Illustrated Parts List - IPL Update

372 XP X-TORQ

503 63 76-03/04

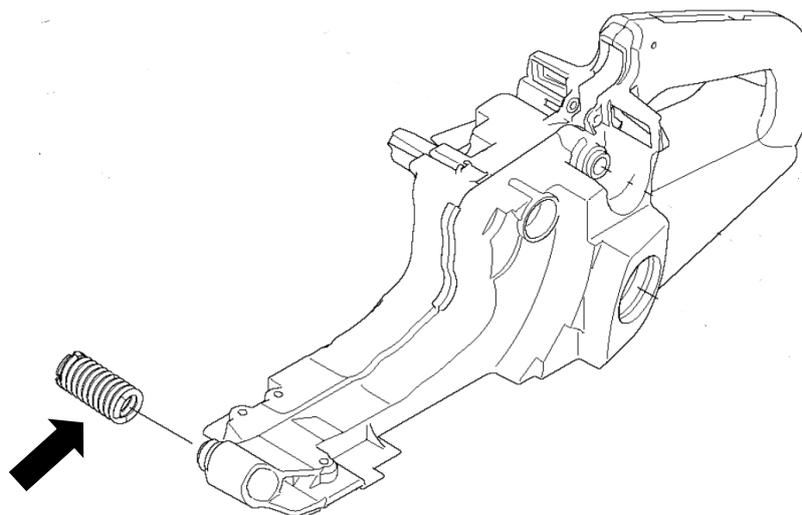
New Antivibration element with ground top on the metal spring. The plastic plug is changed. This gives longer thread length and therefor better fastening of spring in plastic plug.

Reason: Improved durability of antivibration element.

New articles Antivibration element 503 63 76-03 and 503 63 76-04(hard)
